TB 112

TECHNICAL BULLETIN

Product : MRLi Hydraulic Passenger Lifts with NGV valve

Subject : Wiring modification for NGV software version V1.15 R.07

Diagram 1 - Wiring modification for NGV version R.07 pcb (required if previously wired for R.02 pcb)

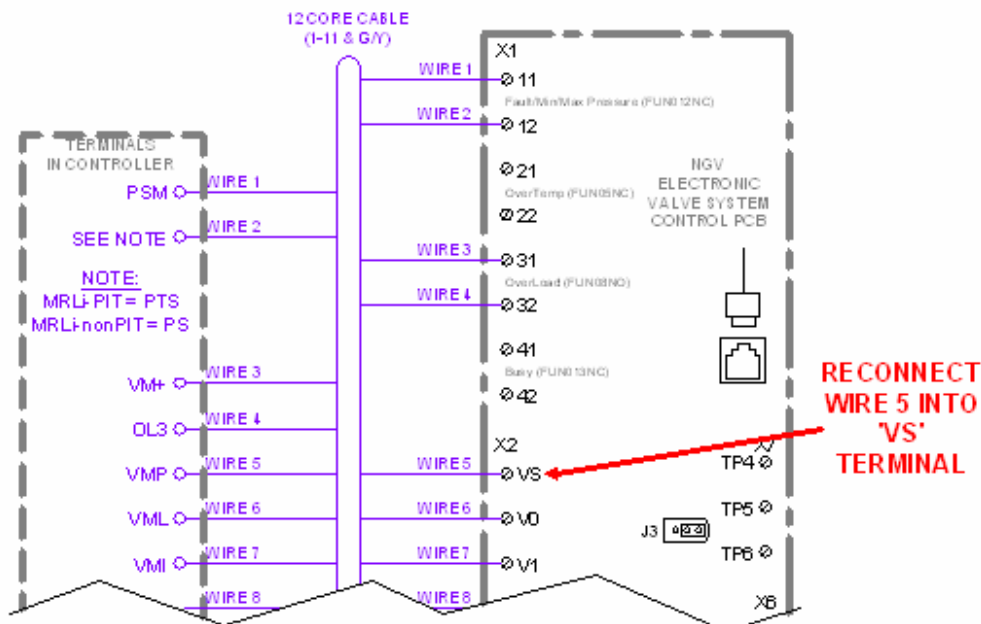
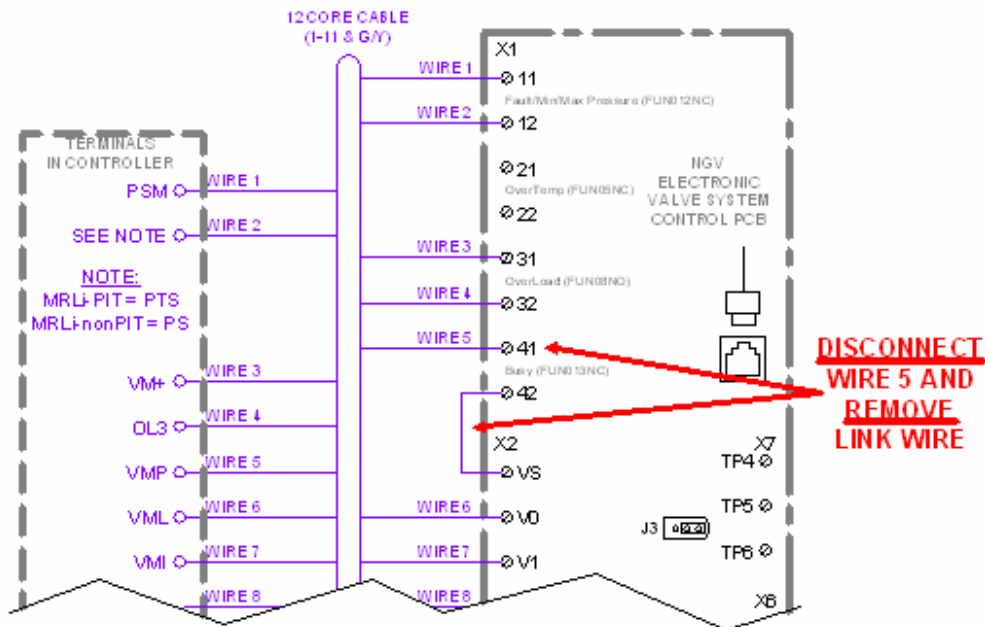
GMV recently introduced a new software version on the NGV pcb - version V1.15 R.07. This has necessitated a change in Stannah's wiring between the lift control panel and the NGV. Without these wiring modifications the valve fails to receive a VS signal. This will result in the lift platform not running up on the first attempt - on subsequent attempts it may run up at rated speed.

For details of how to modify connections from 9333/738 revision A (R.02) to revision B (R.07) please refer to diagram 1 in this bulletin.

R.07 pcb's must be wired in accordance with 9333/738 revision B. A copy of this wiring diagram is included with this bulletin.

Note: If an attempt to run the lift platform was made prior to the wiring modification, a red flashing LED will be observed on the pcb indicating a fault condition. The NGV alarm log must be reset to clear this fault - **attempts to run the platform when the red LED is flashing may result in the lift platform running up at rated speed.** The alarm log is cleared using menu 3 with the hand held programmer - see GMV's "NGV Installation Manual" for details.

NAME: S. JACKSON	DATE: 29/07/09
CHECKED: G. COOPER	DATE: 29/07/09
MOTOR ROOM WIRING - GMV NGV ELECTRONIC VALVE SYSTEM	
Stannah	
HEAD OFFICE: Anton Mill Andover Hampshire SP10 2NX England	
Tel: 01264 339090 Fax: 337942	
DRAWING NO: 9333/738	REV: B

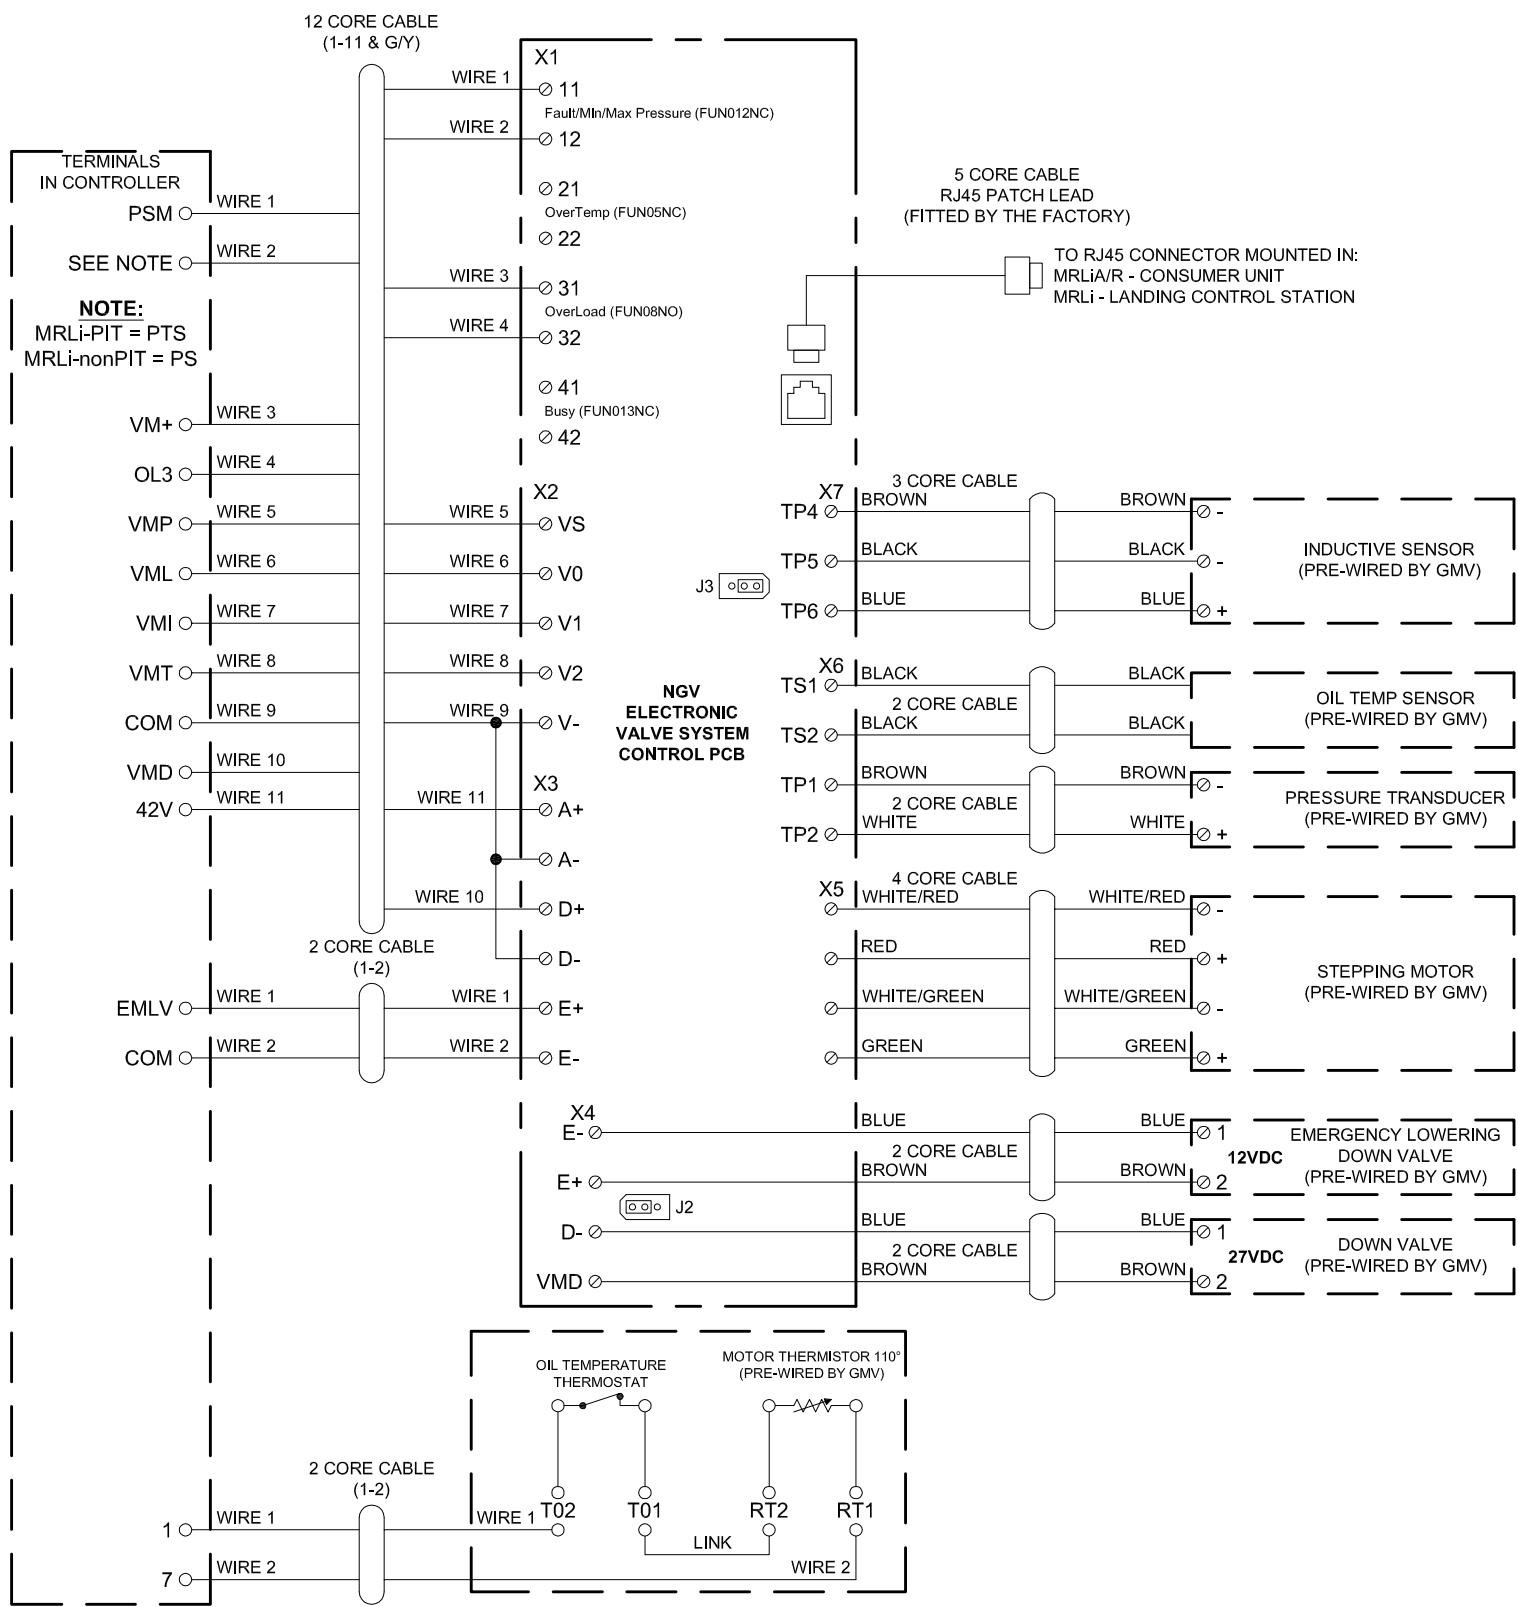
REV B: TERMINALS '41' & '42' NO LONGER USED. WIRE 5 NOW CONNECTED STRAIGHT TO 'VS'
 31/05/11 SAJ.

REV A: EMERGENCY LOWER CONNECTIONS AMENDED. DOWN VALVE VOLTAGE CHANGE TO 27VDC.
 NEW LOGO & TEXT FONT CHANGED. 18/08/10 SAJ.
